TOWN OF ERIE

25-604 PUBLIC HEARING: Resolutions of the Planning Commission Recommending Approval of a Site Plan and Special Review Use for the Erie Police Department Station Expansion with a Condition

SUBJECT:	**PUBLIC HEARING: SRU2025-00001; SP2025-00009** **Resolutions of the Planning Commission Recommending Approval of a Site Plan and Special Review Use for the Erie Police Department Station Expansion with a Condition.**
CODE REVIEW:	Erie Municipal Code, Title 10
PURPOSE:	Consideration of a proposal to expand the Erie Police Department Station with an approximate 17,000 square-foot addition and associated site improvements. This public hearing includes two applications – a Special Review Use to permit an expansion of the use and a Site Plan that details the development of the site and building addition.
DEPARTMENT:	Planning and Development
PRESENTER:	Harry Brennan, Senior Planner

SHEET IDENTIFICATION
C-304

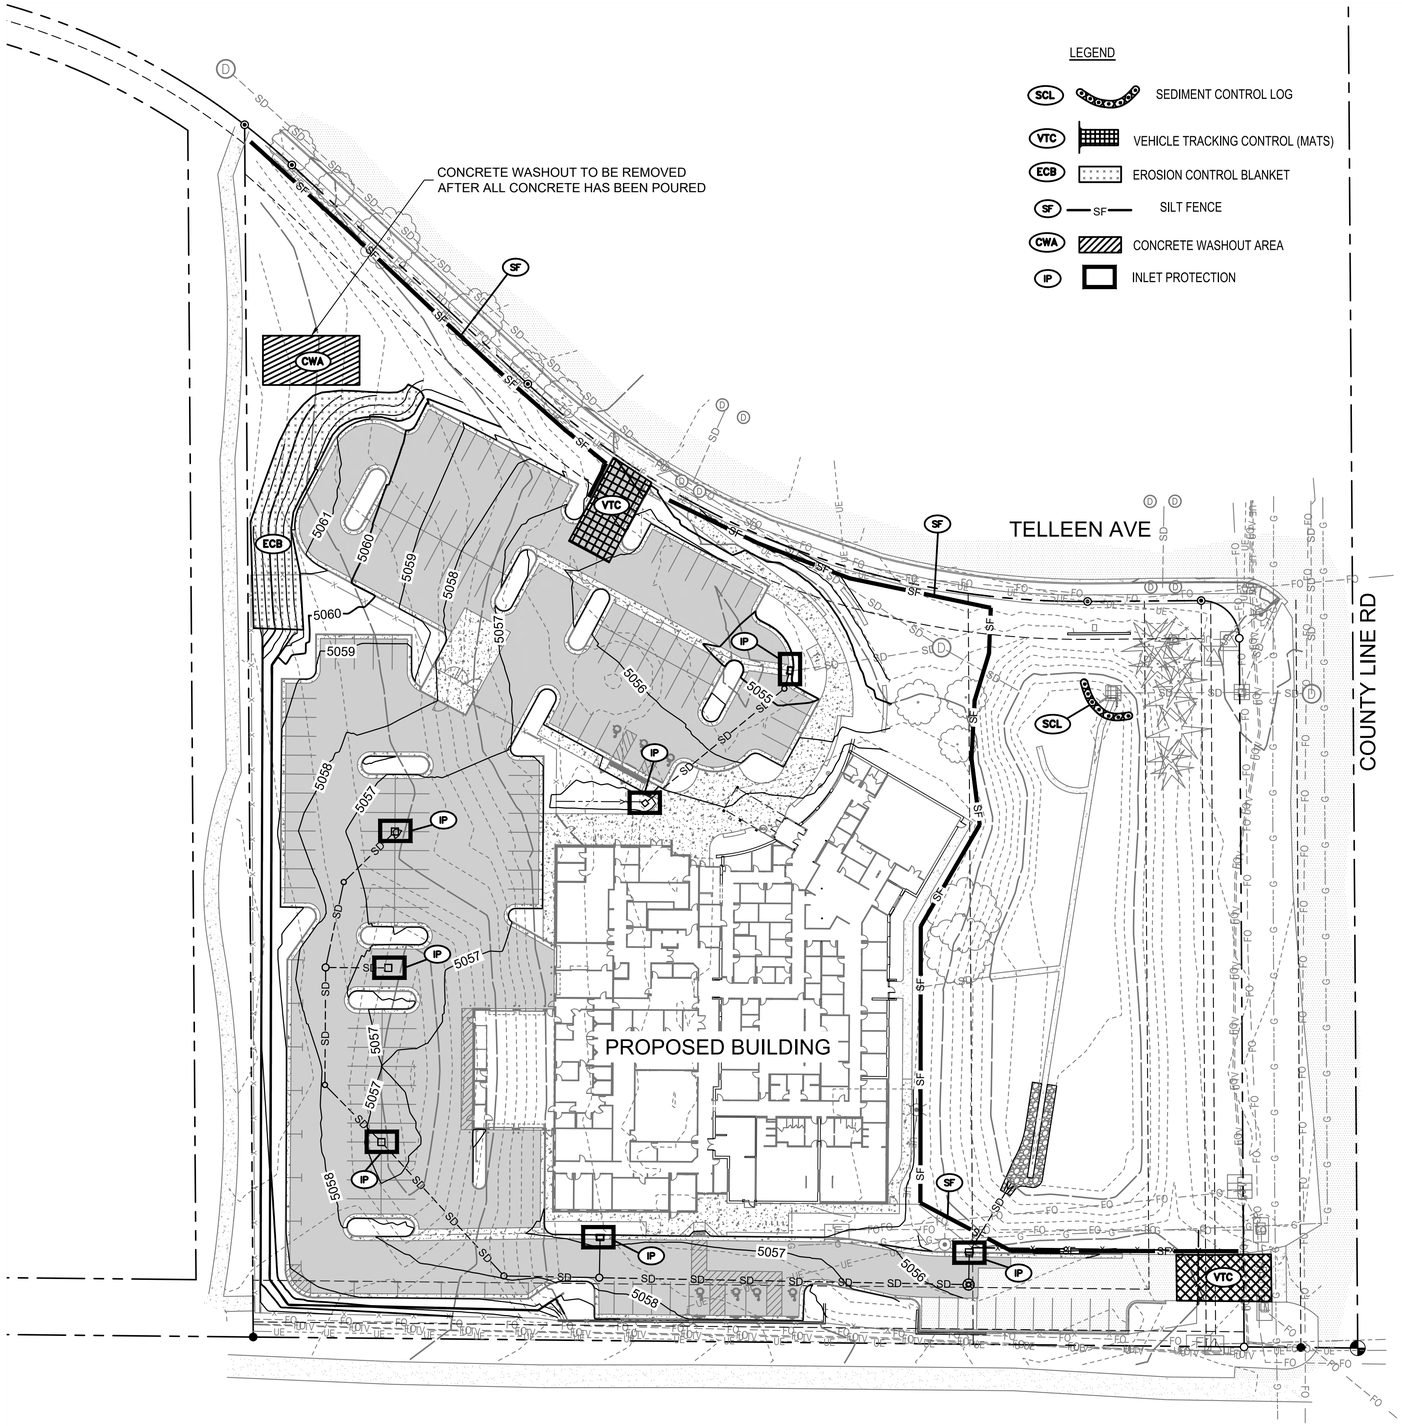
1. General comments- please identify seed mix for the detention pond. There will be disturbances that will require restoration.
2. Sheet C-304- Identify IP and VTC as initial control measures.

SHEET IDENTIFICATION
C-405

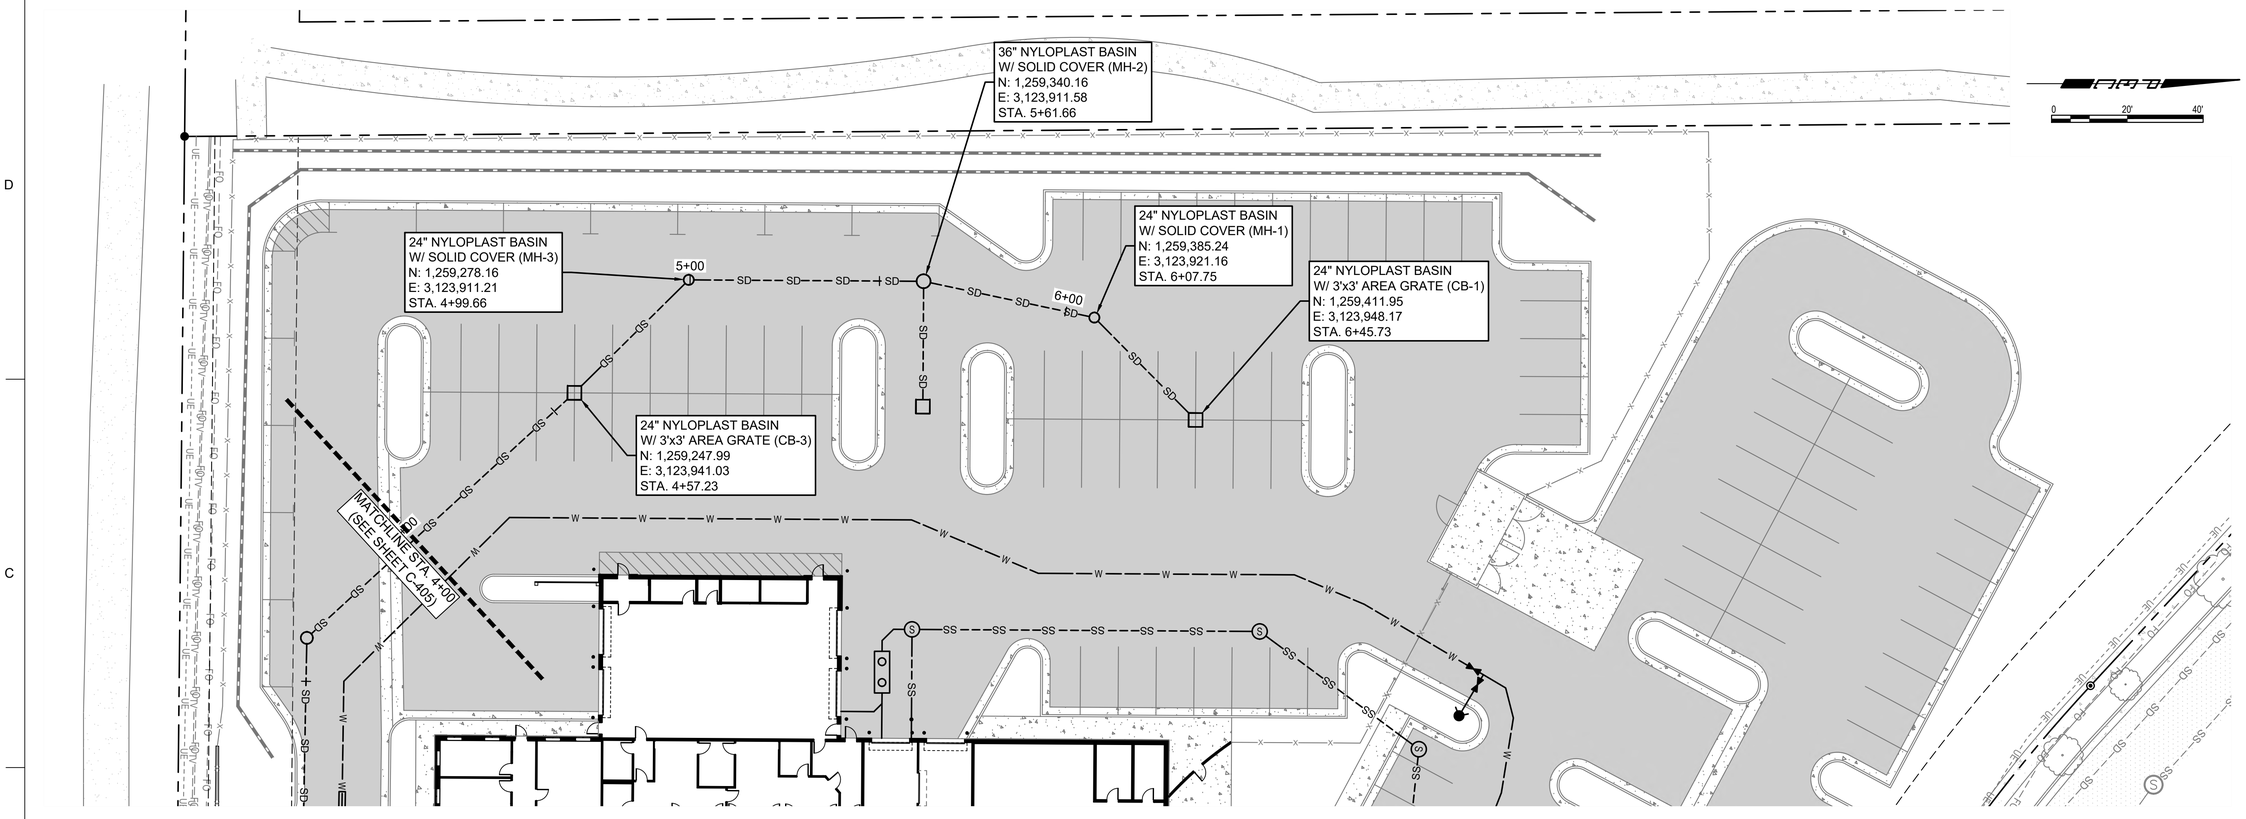
9. On Sheet C-405, 30" CPP at 0.42% slope is proposed. We suggest using RCP for storm pipes greater than 24" diameter, especially when installed at a relatively flat slope as proposed.

1. On sheet C-405, please:
    a. Include a toe wall at the invert of the pipe to frost depth per MHFD criteria Vol 2, Fig 9-29 through 9-33.
    b. Show the forebay in the profile with the concrete pan.
    c. Confirm that the existing concrete pan will tie into the corner of the forebay. It is best if the concrete pan ties into the middle of the forebay near the notch to convey stormwater to the outlet structure. See also comment number 6 of General Stormwater Report Comments
2. MHFD is curious for the need of a riprap rundown and a baffle wall in the forebay. Please expand on the discharge velocity of the pipe based on Appendix F and the need for additional outlet protection outside of the forebay.
3. On sheet C-416, please:

a. All storm sewer pipes have been revised to RCP.
10. On Sheets C-406 and C-408, at Inlets CB-1 and CB-2 provide minimum 24" cover for HDPE pipe (Section 815.03).

LS001

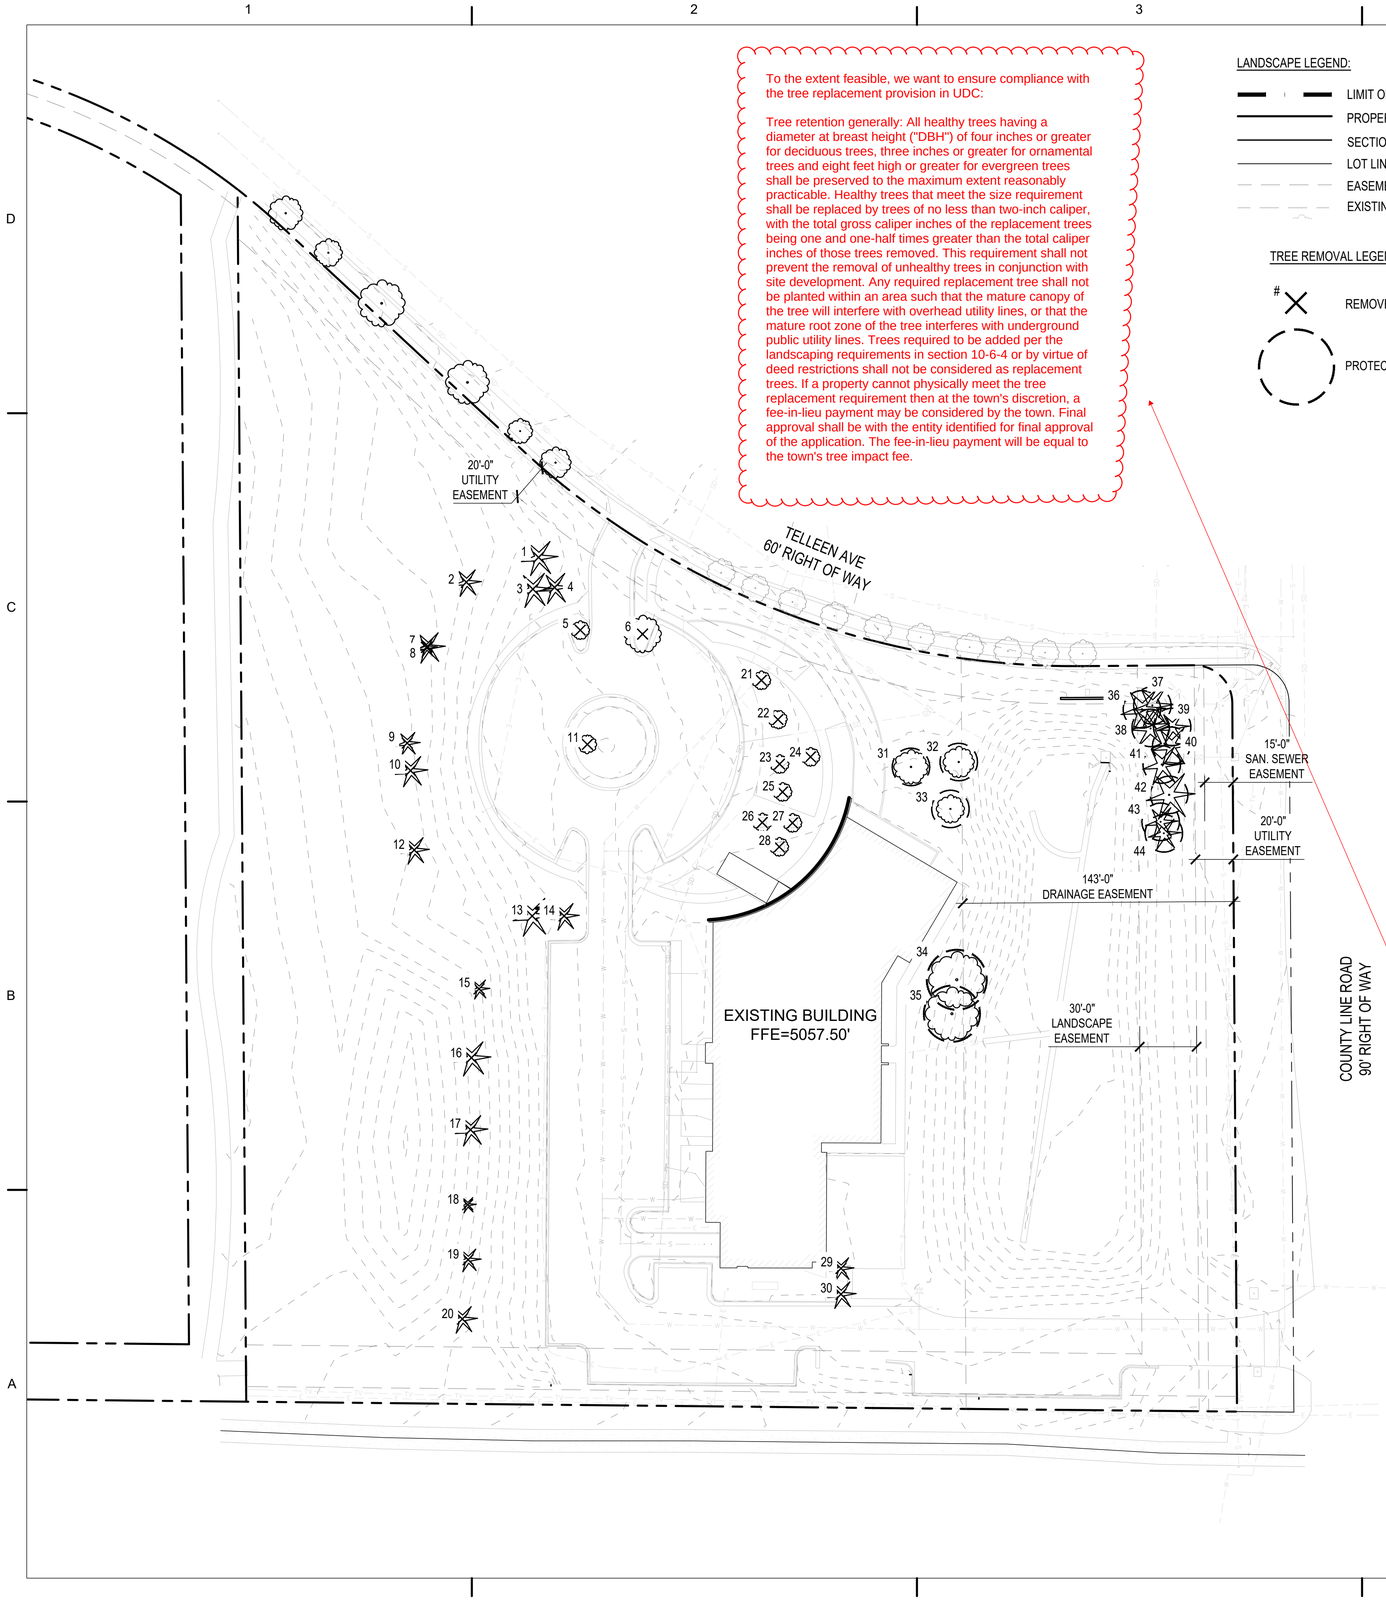
To the extent feasible, we want to ensure compliance with the tree replacement provision in UDC:

Tree retention generally: All healthy trees having a diameter at breast height ("DBH") of four inches or greater for deciduous trees, three inches or greater for ornamental trees and eight feet high or greater for evergreen trees shall be preserved to the maximum extent reasonably practicable. Healthy trees that meet the size requirement shall be replaced by trees of no less than two-inch caliper, with the total gross caliper inches of the replacement trees being one and one-half times greater than the total caliper inches of those trees removed. This requirement shall not prevent the removal of unhealthy trees in conjunction with site development. Any required replacement tree shall not be planted within an area such that the mature canopy of the tree will interfere with overhead utility lines, or that the mature root zone of the tree interferes with underground public utility lines. Trees required to be added per the landscaping requirements in section 10-6-4 or by virtue of deed restrictions shall not be considered as replacement trees. If a property cannot physically meet the tree replacement requirement then at the town's discretion, a fee-in-lieu payment may be considered by the town. Final approval shall be with the entity identified for final approval of the application. The fee-in-lieu payment will be equal to the town's tree impact fee.
